Addendum #2

March 22, 2023

Genoa Bank
Fremont Branch
1701 West State Street
Fremont, OH 43420
DAP Project No. 22019

Drawing C-7 *(reissued)*

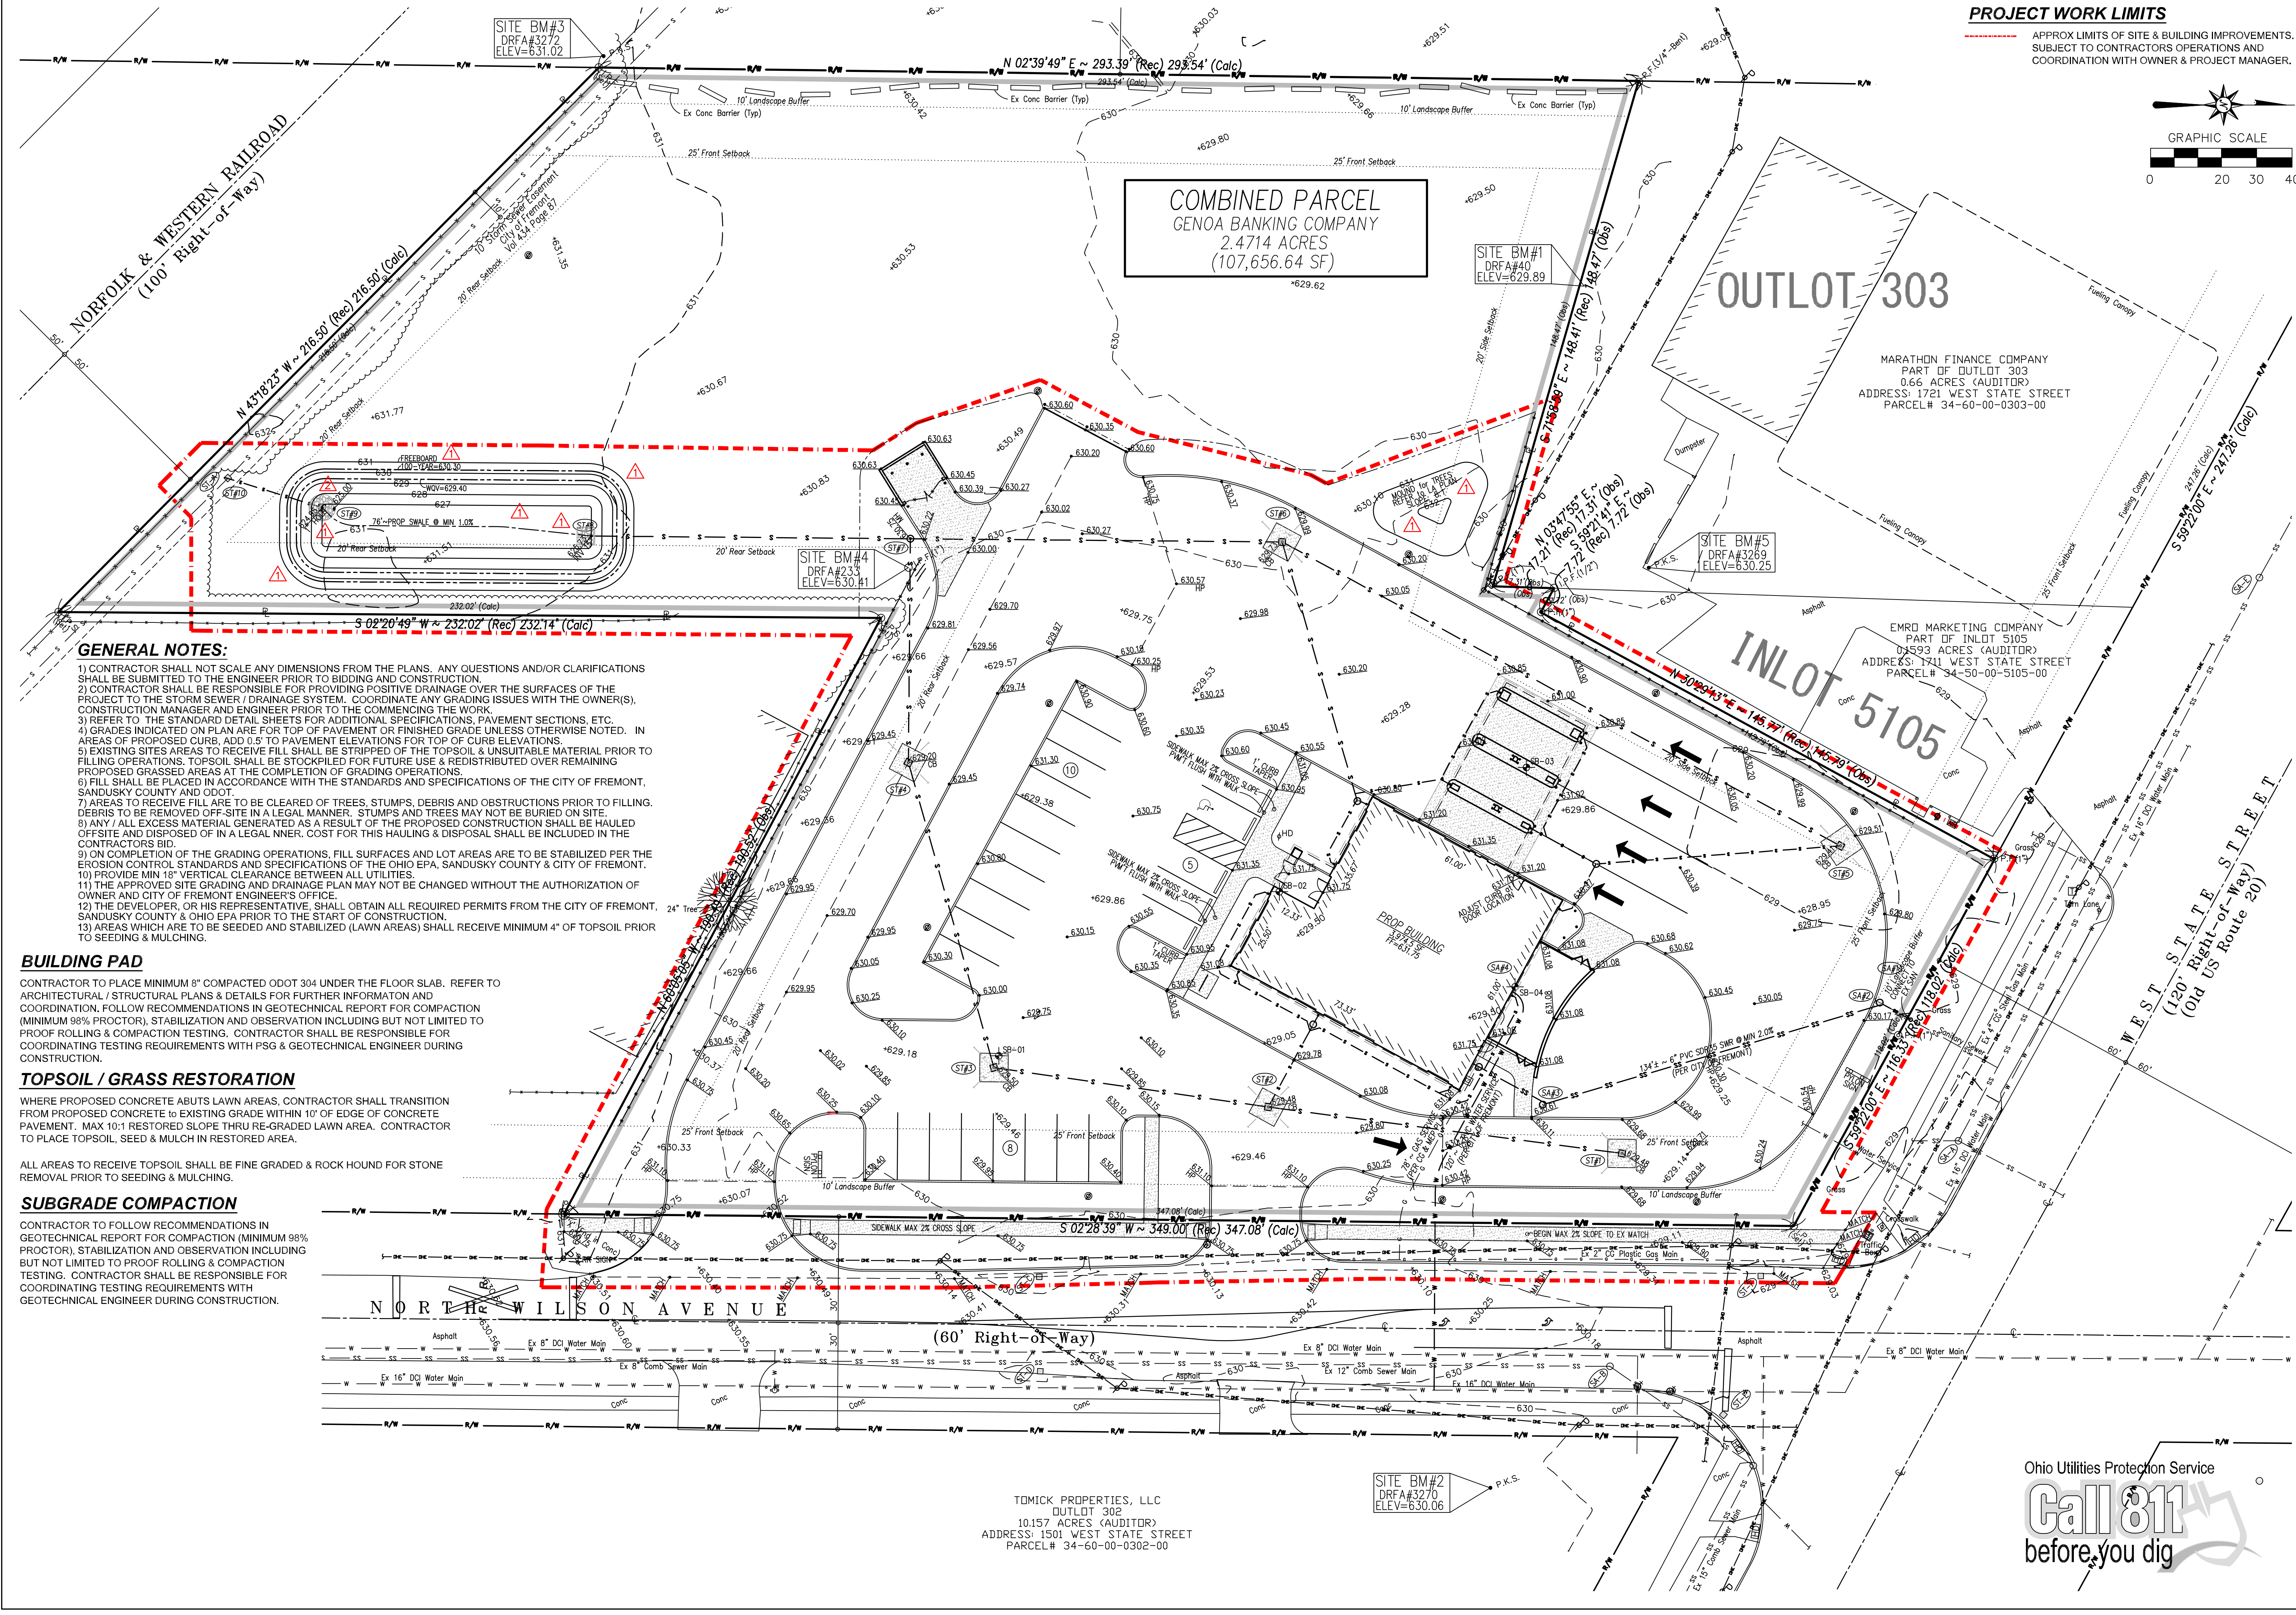
- Item 1: Revised spot elevation in front of ST#9 from 626.00 to 625.00.
- Item 2: Adjusted the alignment of the swale to the centerline of the detention basin instead of a direct line from ST#8 to ST#9.
